CALIFORNIA COASTAL COMMISSION

STAFF REPORT AND RECOMMENDATION  
ON CONSISTENCY DETERMINATION

Consistency Determination  
 No. CD-105-95  
 Staff: LJS-SF  
 File Date: October 26, 1995  
 45th Day: December 10, 1995  
 60th Day: December 25, 1995  
 Commission Meeting: Dec. 14, 1995

DEVELOPMENT DESCRIPTION: General Management Plan for Cabrillo National Monument (N.M.) (Exhibits 2-9)

**Alternative B**  
**Development Concept Plan 3**  
**ENTRANCE STATION RELOCATION:**  
**Site Plan**

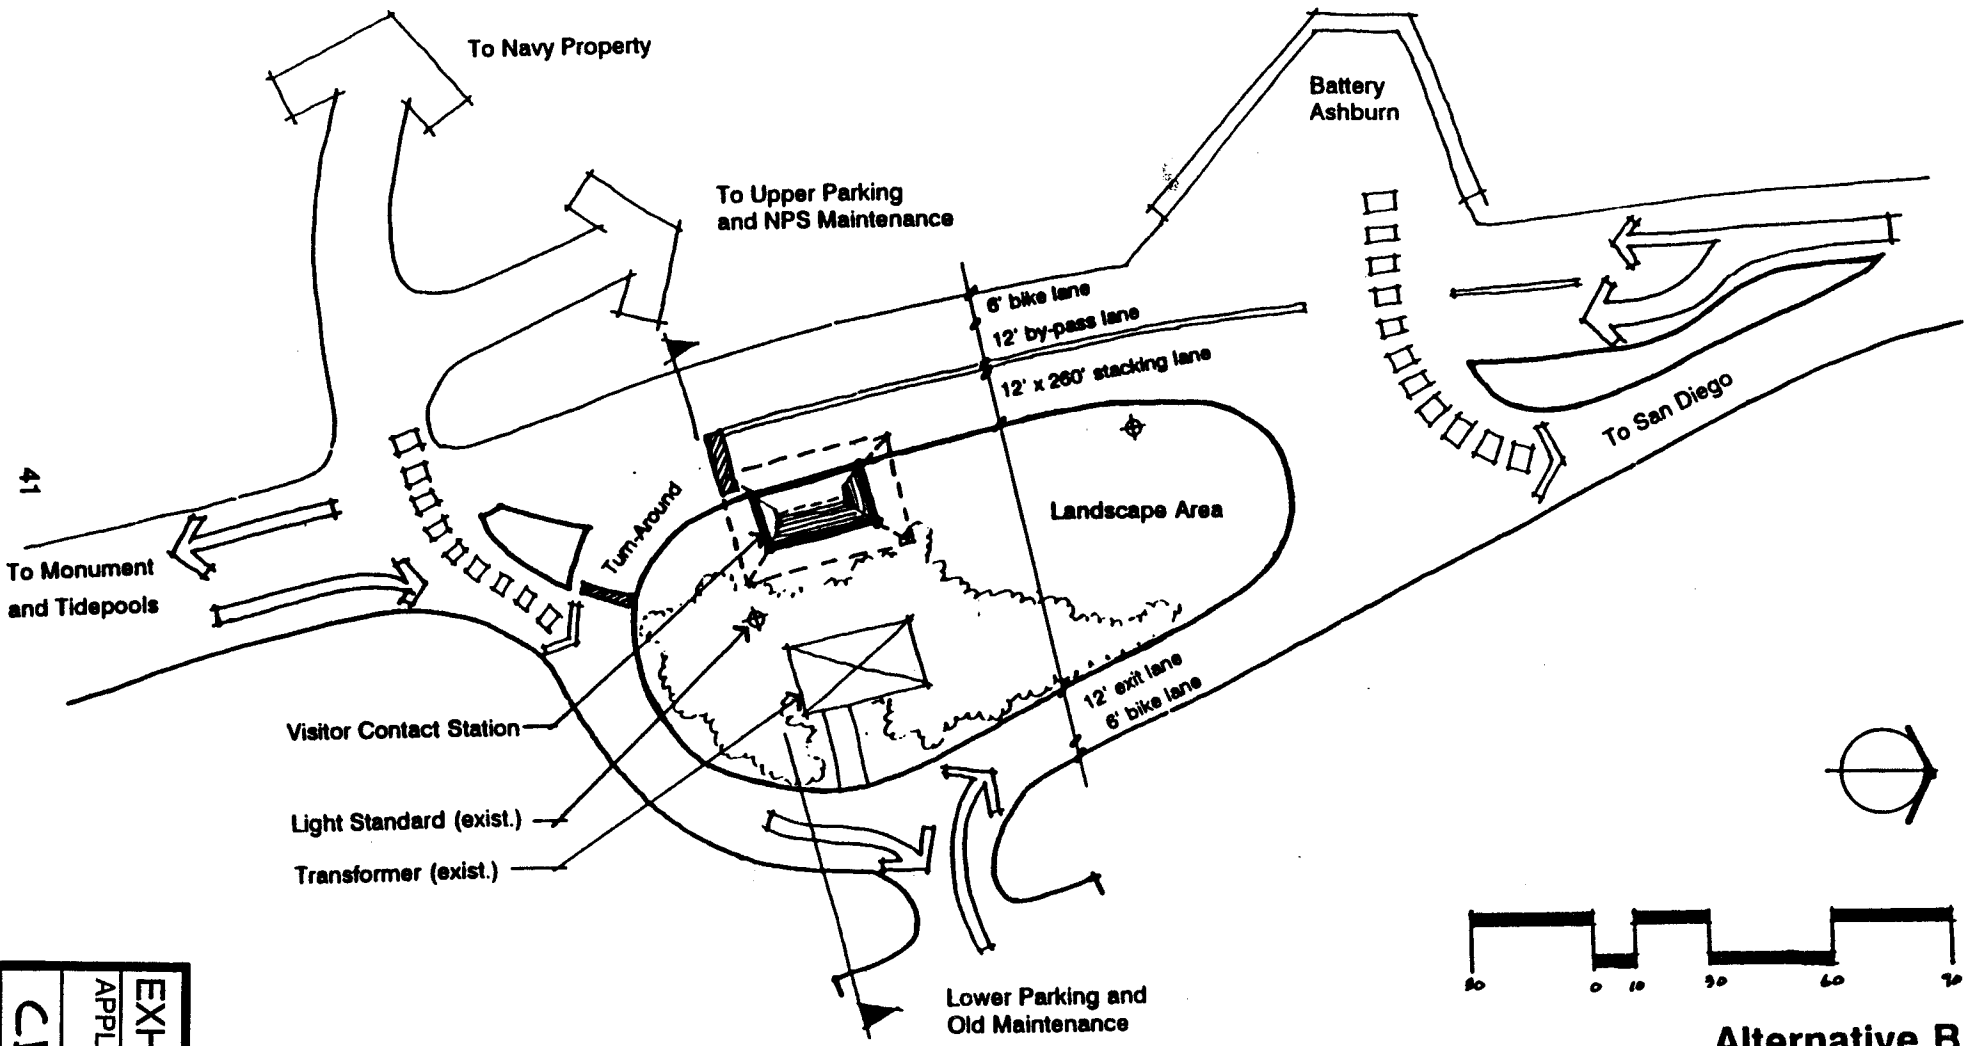
- \* Entrance Station: A new entrance station would be built north of the intersection of Cabrillo Memorial Drive (Route 209) and Cabrillo Road, in order to provide a better orientation to the monument, include the tidepools and western part of the monument in the visitors' perception of the monument, and allow entrance fees to be collected from those who use the tidepools (Exhibit 4).

The Commission believes that the relocation of the entrance station and potential management strategies and development at the tidepool area are GMP elements that carry the potential to adversely affect public access to and recreational use of the monument. At the same time, however, the Commission

To that end, the Commission notes that it will have the opportunity to evaluate detailed plans for construction of a new entrance station, construction of interpretive facilities at the tidepool area, and implementation of visitor management strategies at the tidepool that would affect public access to and recreational use of this area of the monument, in the review of subsequent consistency determinations for these plan components that will be submitted by the NPS. The Commission also notes that the NPS' overall strategy is to enhance recreation and protect fragile coastal resources. The Commission therefore finds that the proposed GMP, with the NPS commitment to subsequent consistency reviews of GMP components (in particular, the entrance station relocation and tidepool management plans), is consistent with the public access and recreation policies of the California Coastal Management Program (CCMP)(Sections 30210-30213 and 30220-30223 of the Coastal Act).

**VISITOR CENTER Alternative B**  
**Development Concept Plan 2**

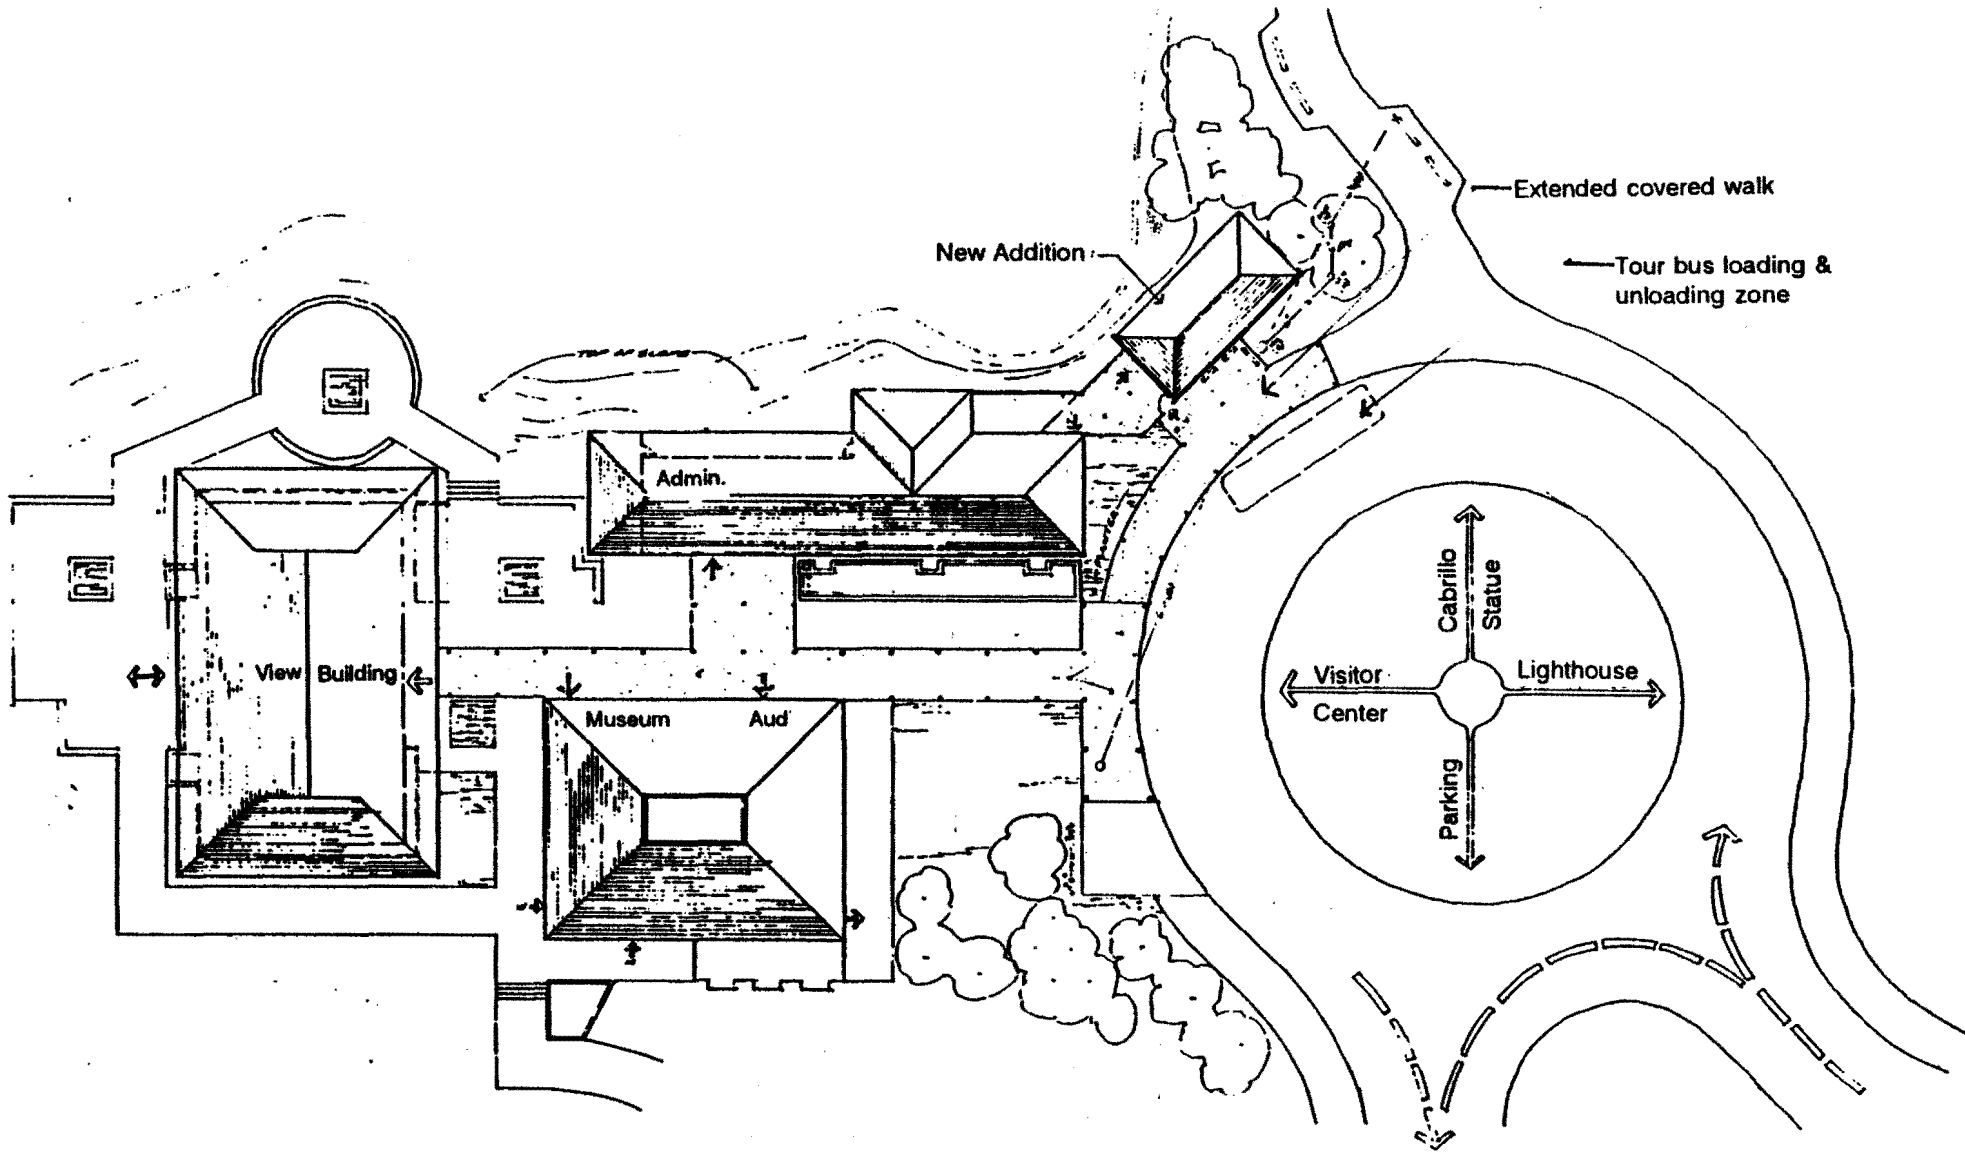
- \* Visitor Center: An improved and expanded outdoor seating area at the Ballast View rest area would be built, and a new building would be built adjacent to the existing administrative building to house resource management, visitor protection, and fee collection activities (Exhibit 5).

Alternative B  
 Development Concept Plan 4  
 WHALE OVERLOOK - Site Plan

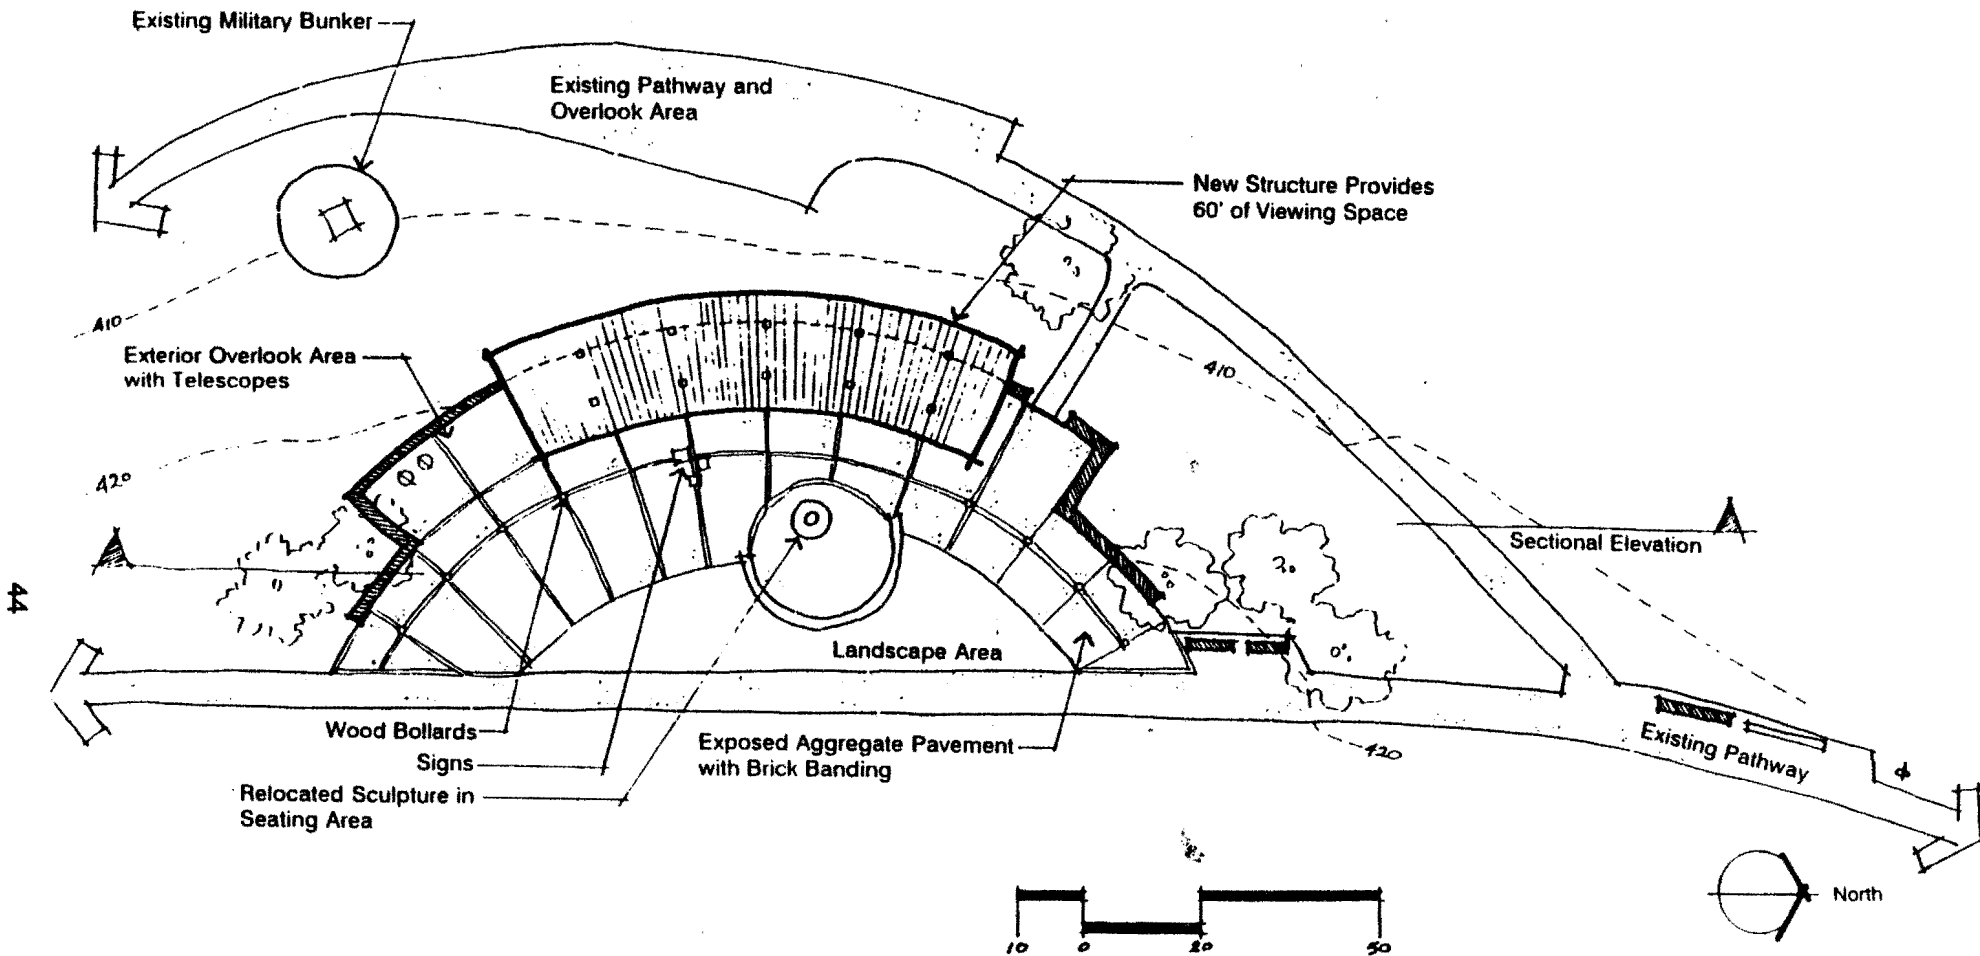
- \* Whale Overlook: The existing structure would be removed and a new structure built to provide sheltered, unobstructed viewing space; additional open viewing platforms would be constructed on either side of the structure (Exhibit 6).

- \* The existing Whale Overlook is too small to accommodate the growing number of visitors who use it, the structure does not fit with the site topography, and its design does not fit with the architectural theme of the visitor center.
- \* Increasing visitor use has led to the establishment of numerous social trails which channel runoff, cause soil erosion, and damage plants.

**OLD LIGHTHOUSE**

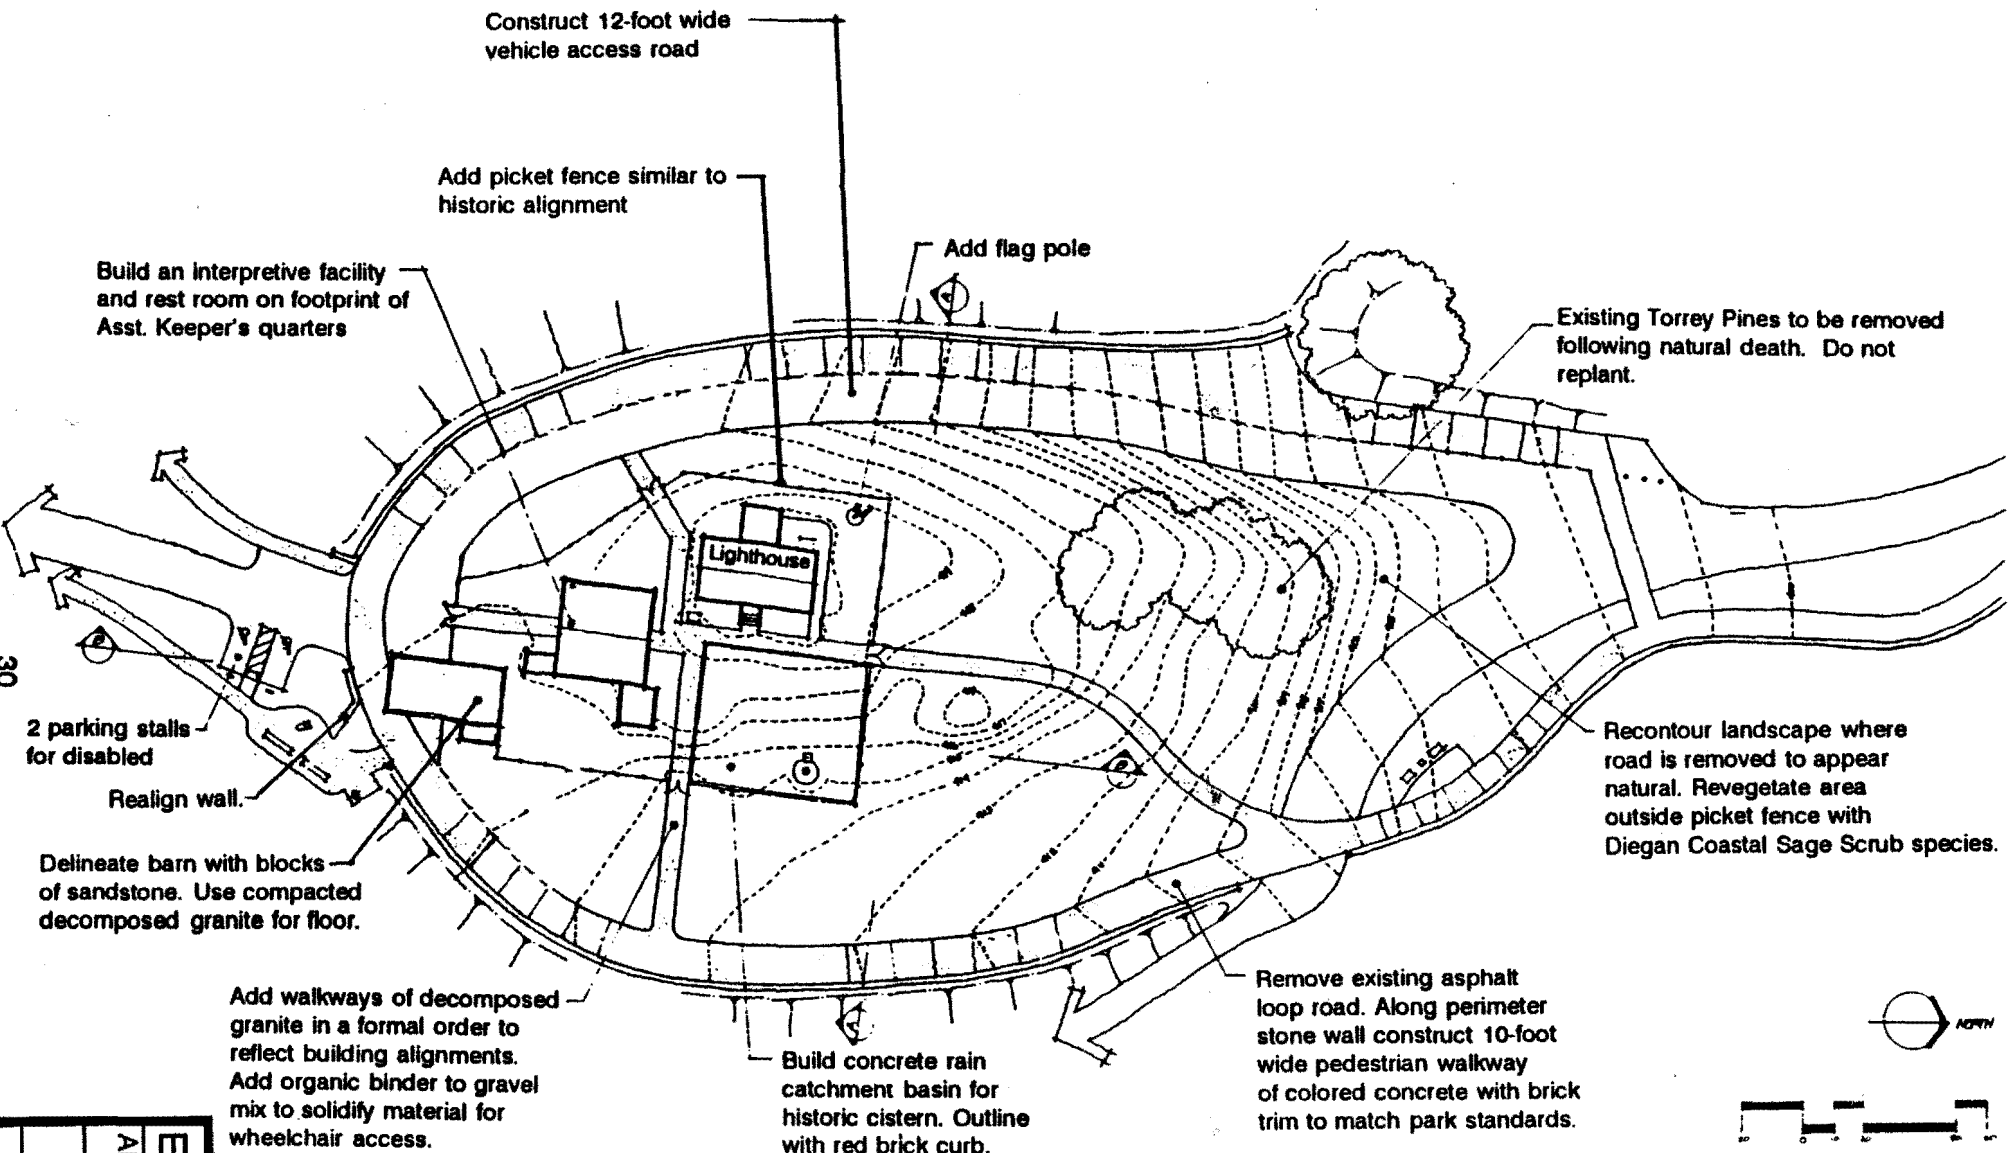
- \* Old Lighthouse: A 1000 square-foot interpretive building would be constructed adjacent to the lighthouse on the footprint of the old assistant lightkeeper's quarters. The developed area around the lighthouse (including roads, fencing, and landscaping) would be modified to reflect the historic 1880s period and to improve access for the mobility impaired (Exhibit 7).

- \* The Old Point Loma Lighthouse exists in a historically inaccurate landscape setting, interpretation is limited by a lack of space to display and explain historical objects, and the structure is not accessible to the mobility impaired.
